1445 NEW YORK AVENUE NW

PROPOSED RENOVATIONS

COMMISSION OF FINE ARTS

CONCEPT REVIEW SUBMISSION

STUDY | PUNCHED BRICK | TO 06

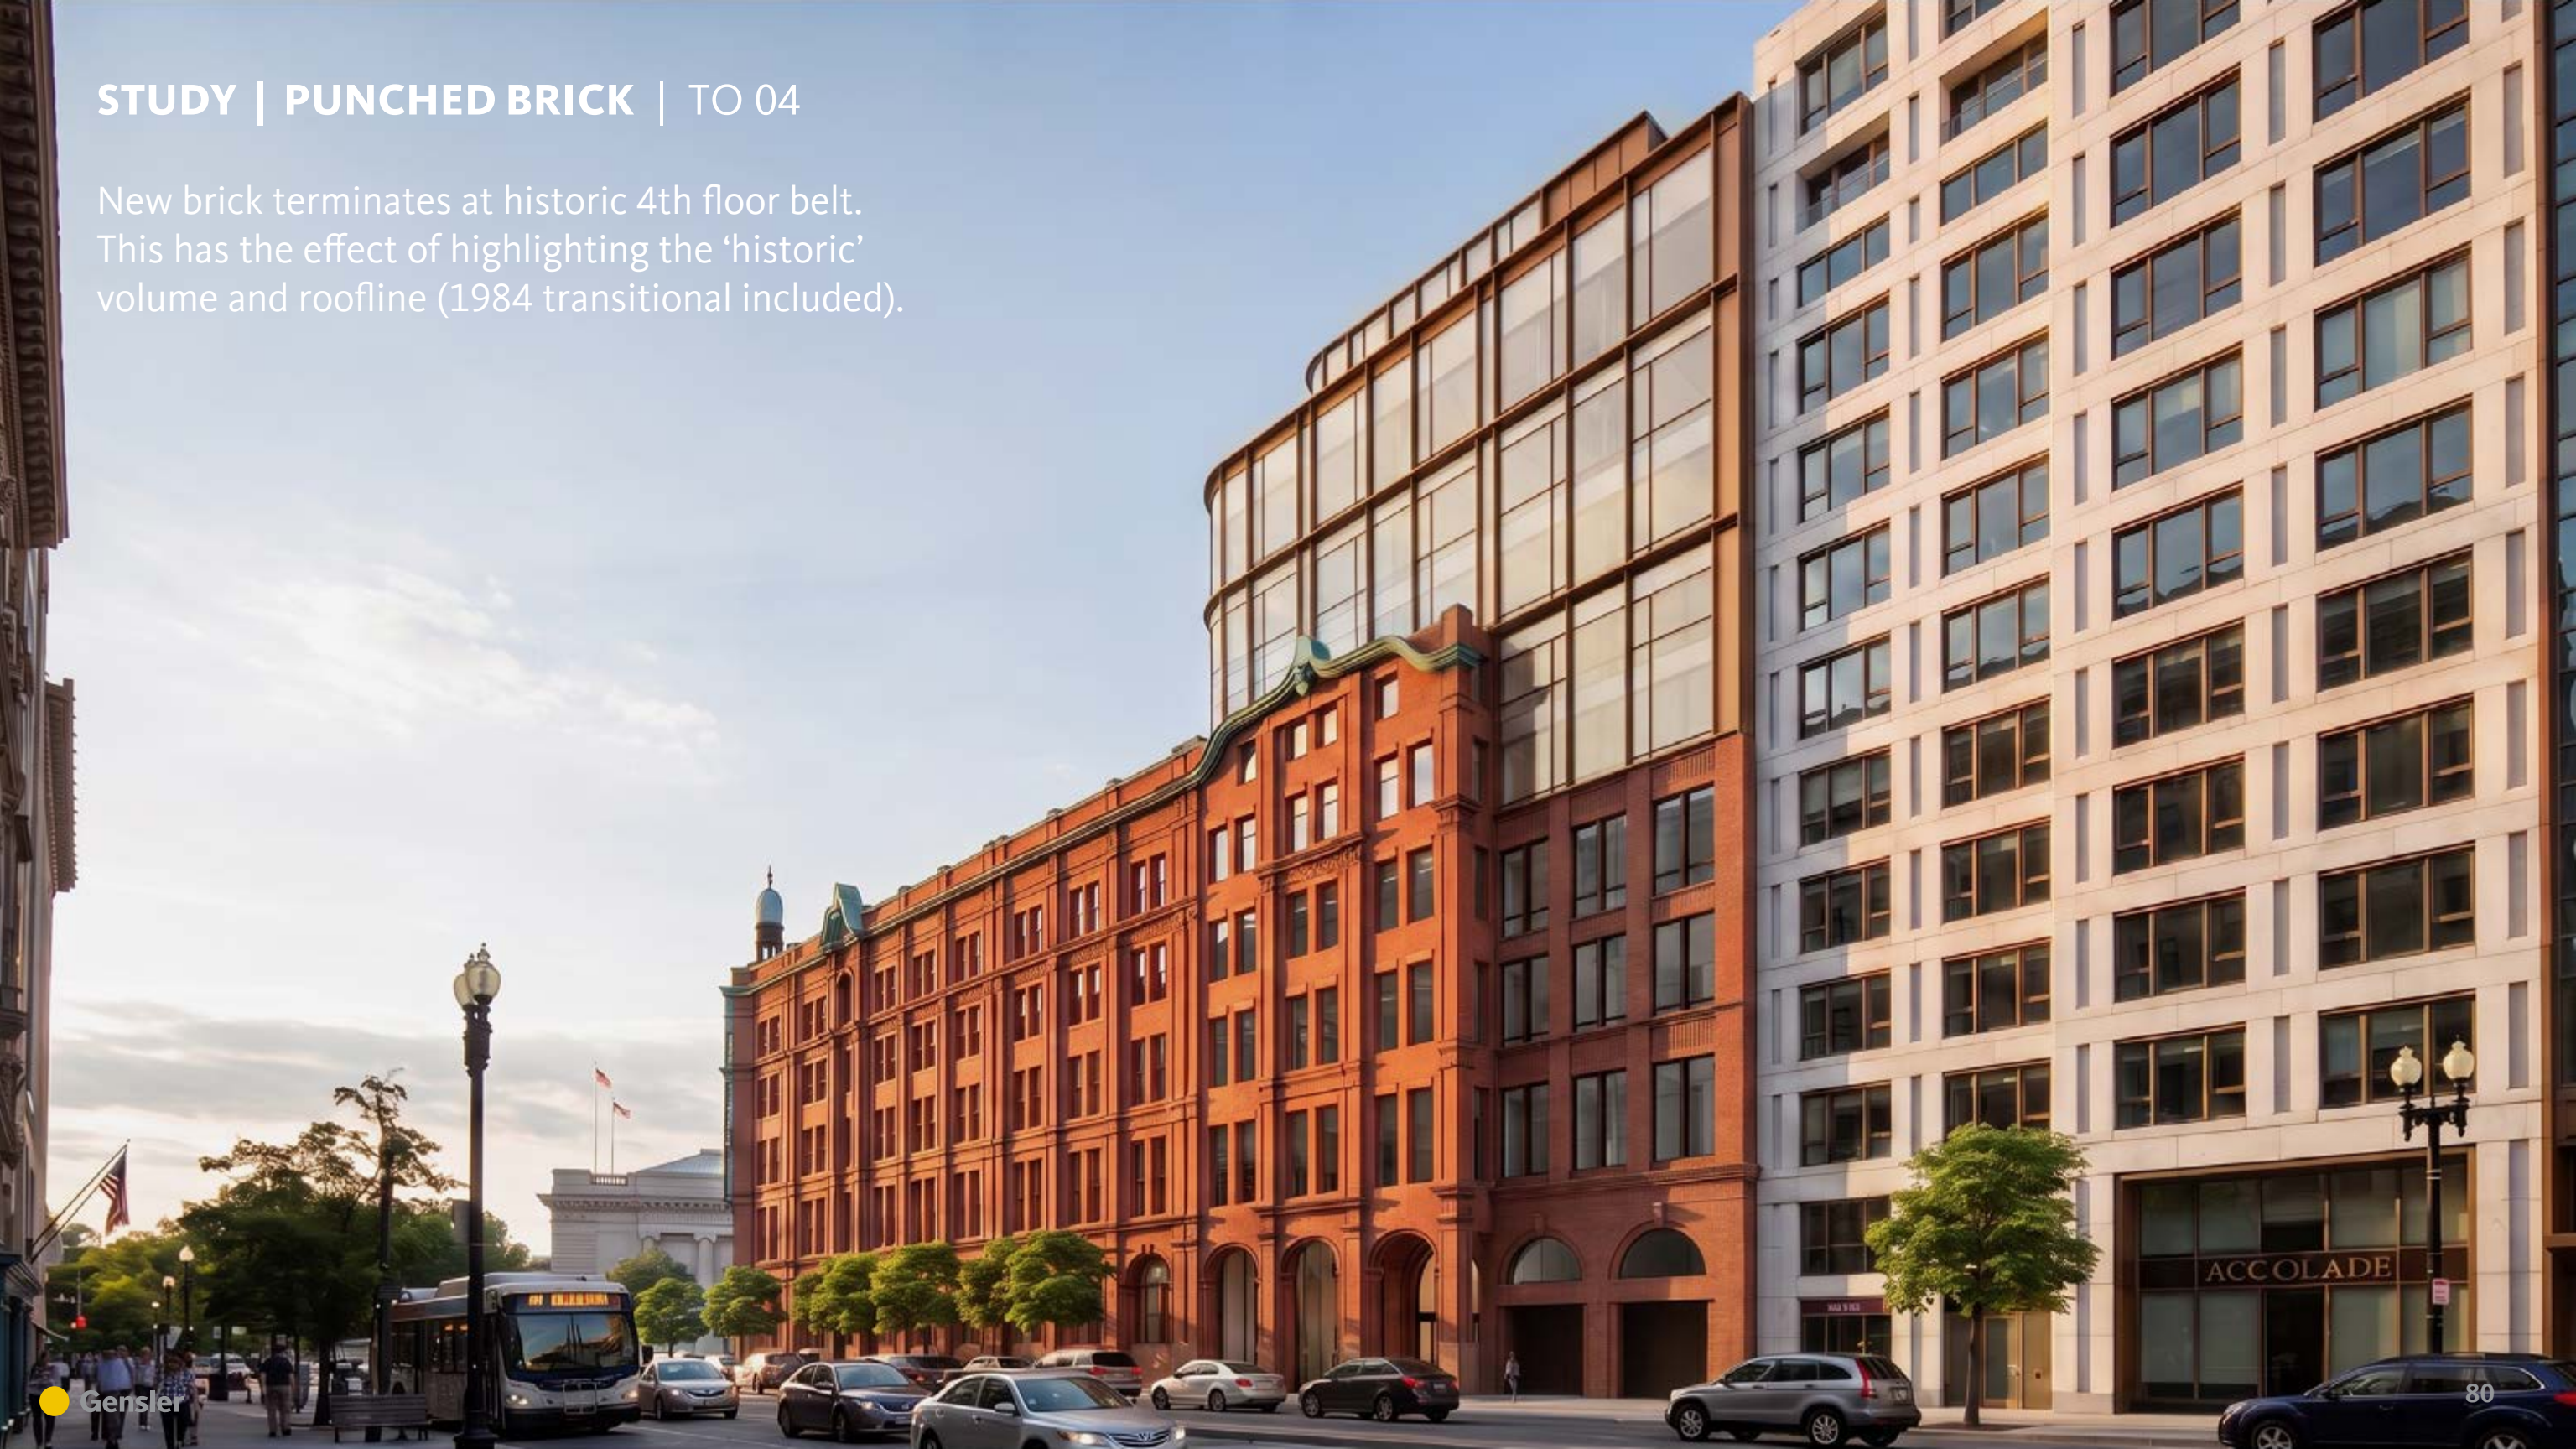
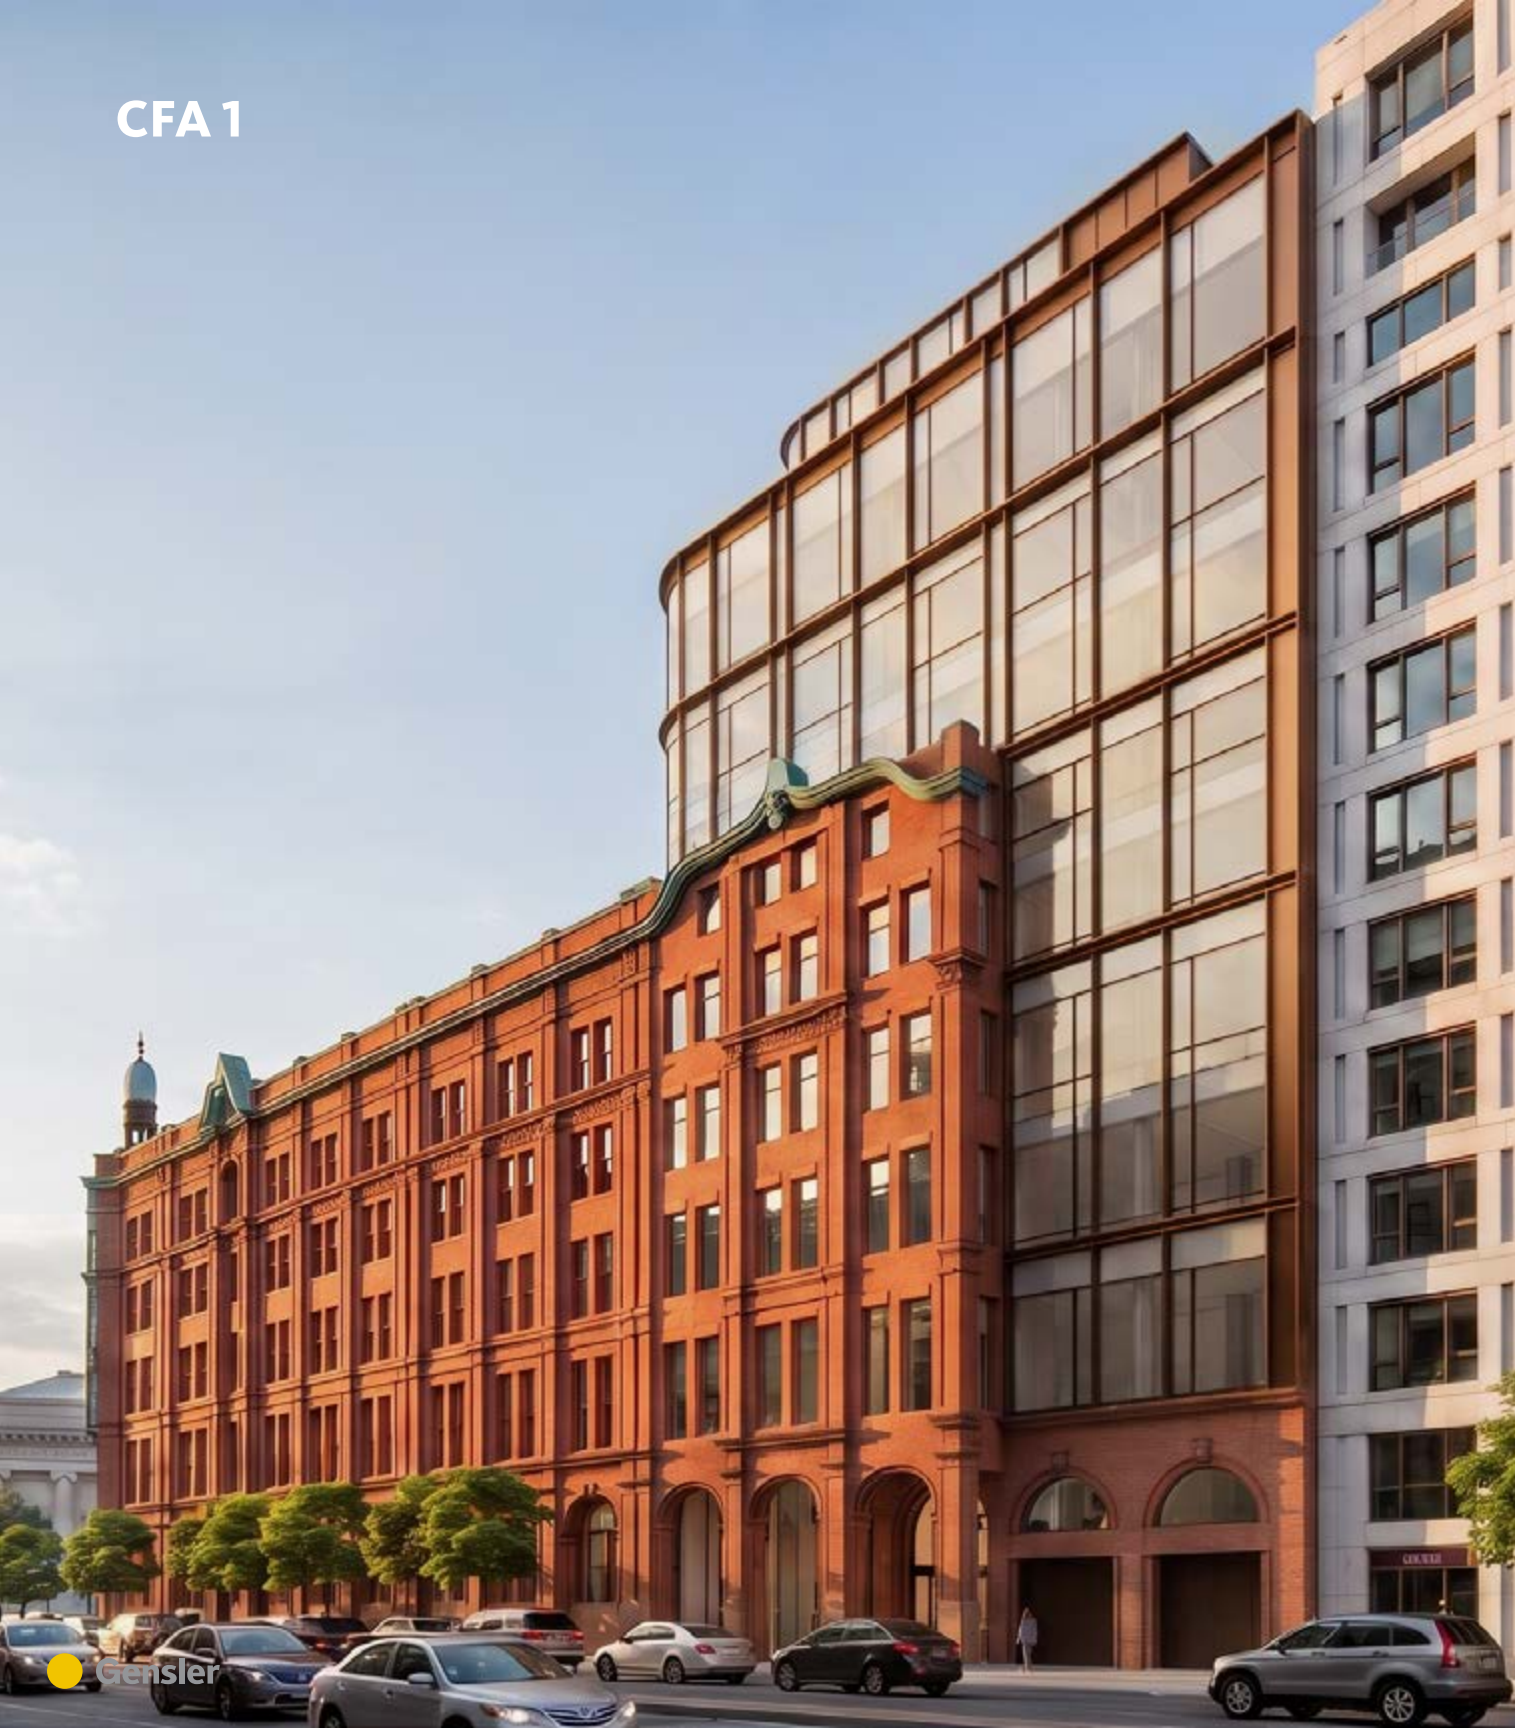
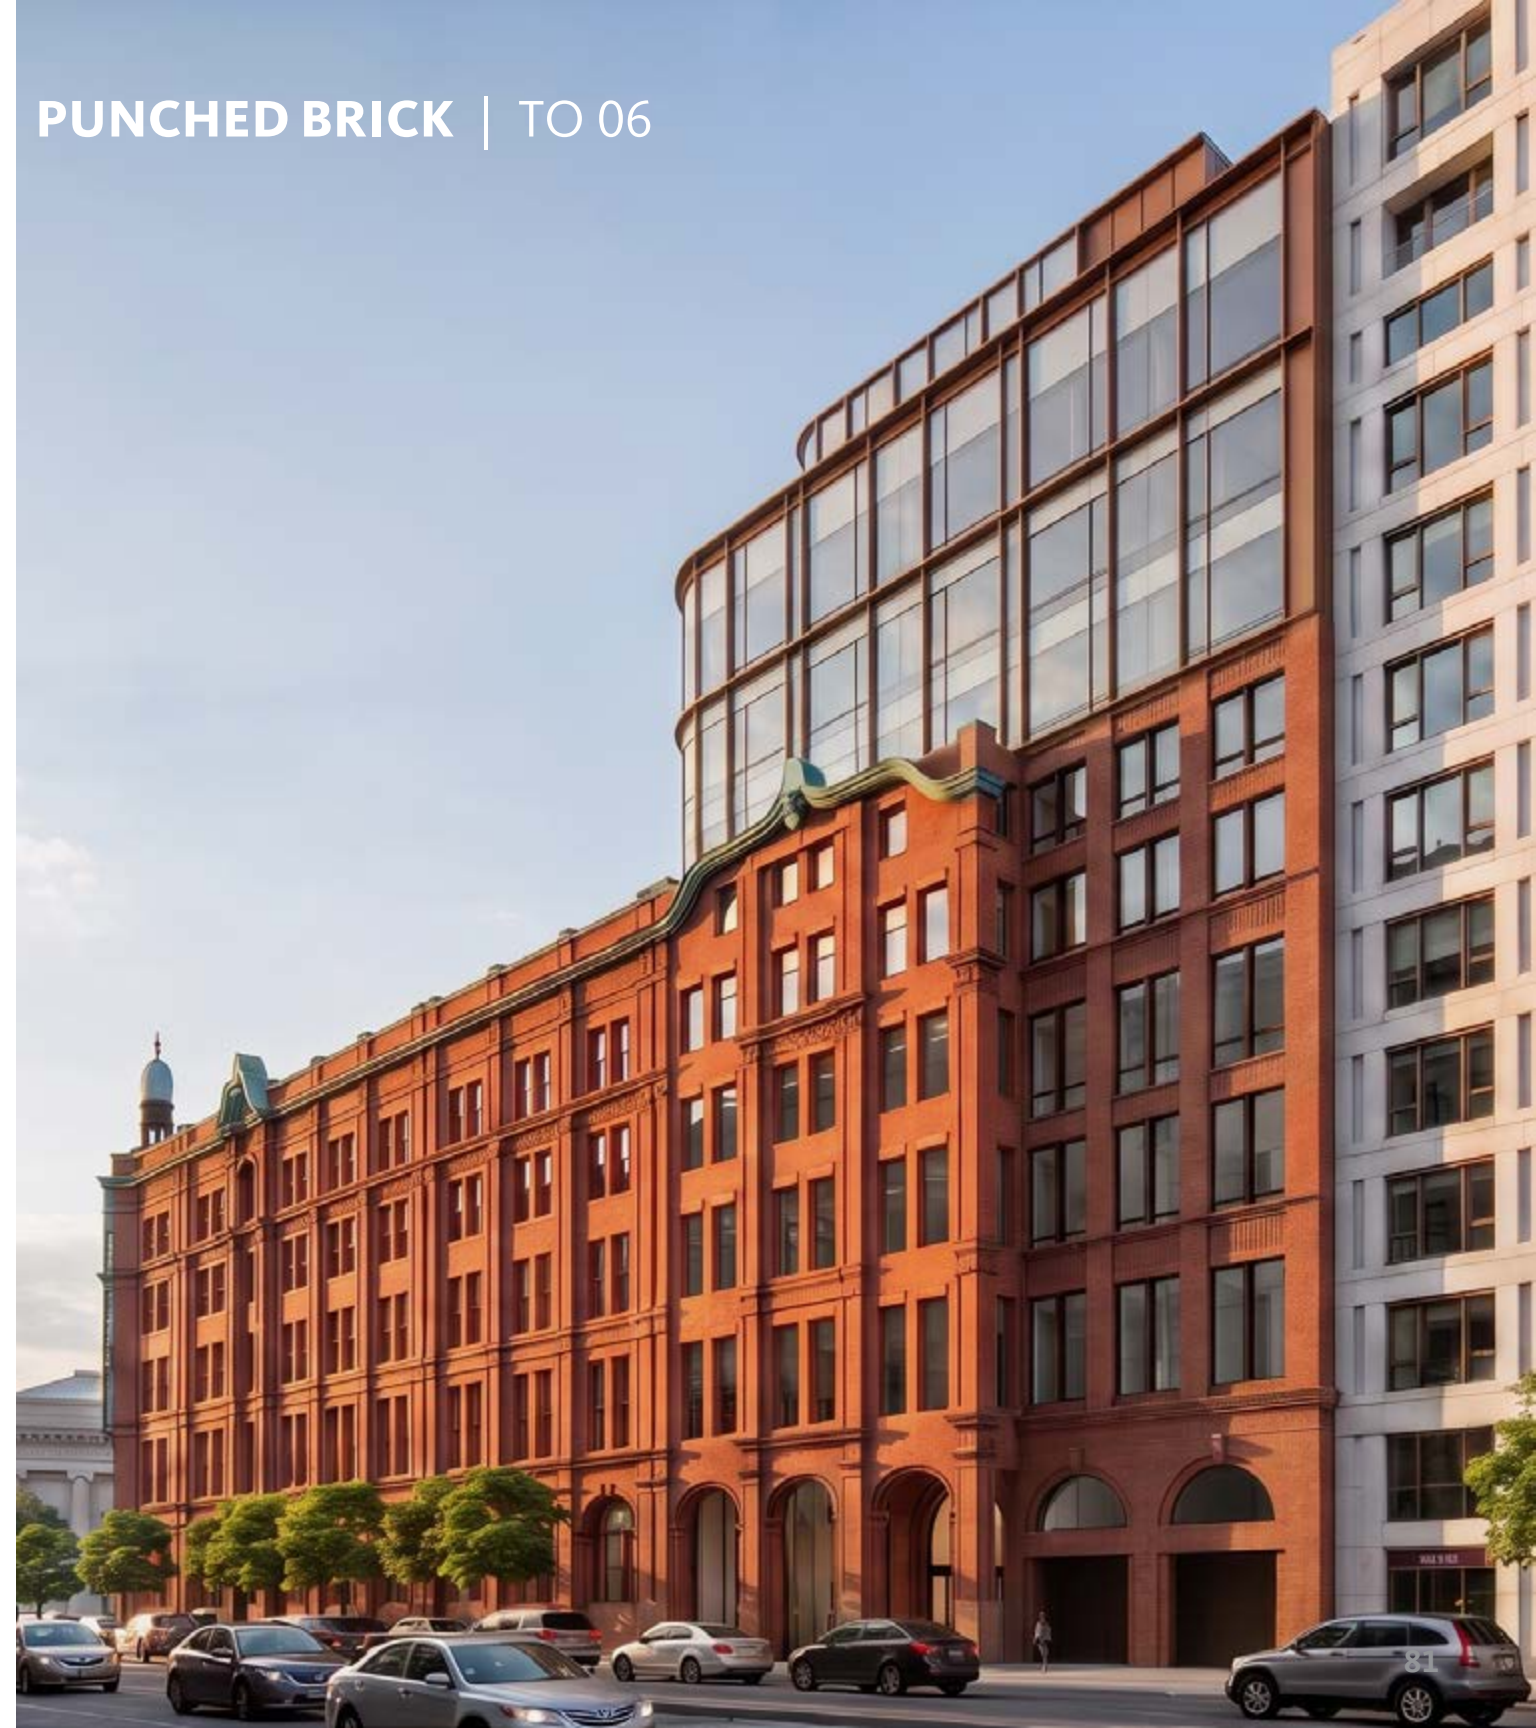
This area is recalling DC's unfortunate history with "façadomies." Study using brick up to the historic roofline and transitioning to glass above. Study extending new façade down to grade.

New brick with paired windows starting at 2nd floor. Advice from DC Historic Preservation was to not directly replicate 1984 transitional. Continuing the copper cornice would slice through 6th floor windows. Match 1984 brick with new or salvaged.

New brick terminates at historic 4th floor belt. This has the effect of highlighting the 'historic' volume and roofline (1984 transitional included).
